UNITED STATES PATENT AND TRADEMARK OFFICE

APPLICATION NO.	FILING DATE	FIRST NAMED INVENTOR	ATTORNEY DOCKET NO.	CONFIRMATION NO.
10/554,114	09/28/2006	Michael A. Hoopes	18801-00733	9365

Office Action Summary	Application No. 10/554,114	Applicant(s) HOOPES ET AL.	
	Examiner Tony H. Winner	Art Unit 3611

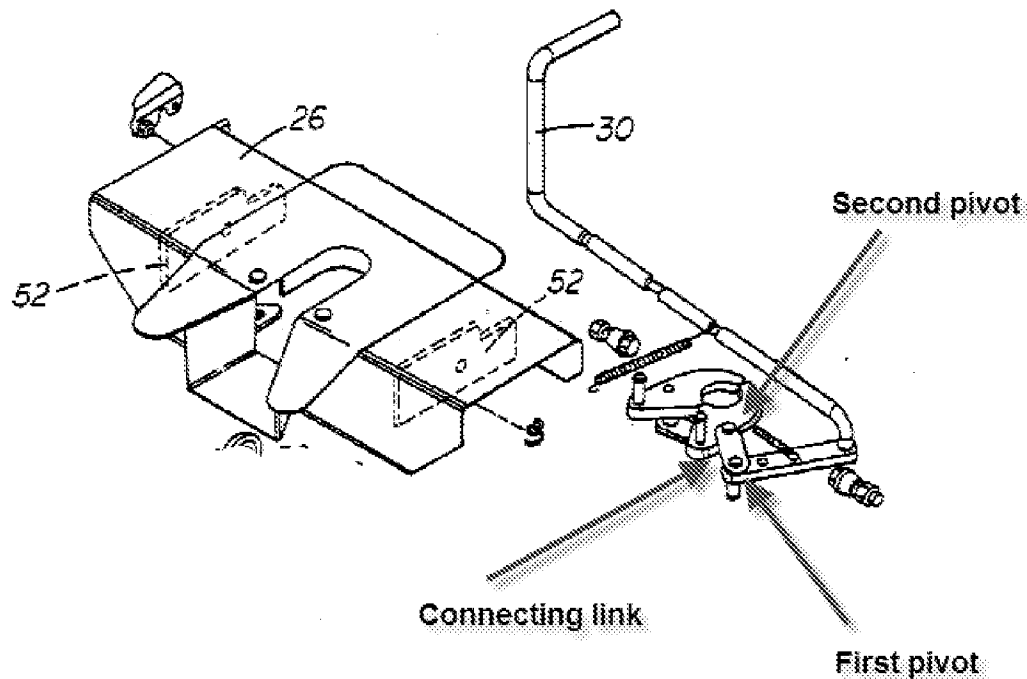
McCoy discloses a fifth wheel hitch assembly, the structure comprising:

- a. a base assembly (12);
- b. a head assembly (26) connected to said base assembly, said head assembly having a slot (cut away portion of element 52 of figure 2); and

c. a jaw assembly (28) connected to said head assembly, said jaw assembly comprising:

- i. a jaw body having a bearing surface for engaging a king pin of a trailer;
- ii. a control handle (30) having a notch that is engageable with said head

assembly by shifting said control handle transversely in said slot; and

iii. a connecting link (figure 2) , said connecting link being pivotally connected to said control handle by a first pivot pin and to said jaw body by a second pivot pin.

McCoy lacks stepped bearing surface with regard to the jaw body.
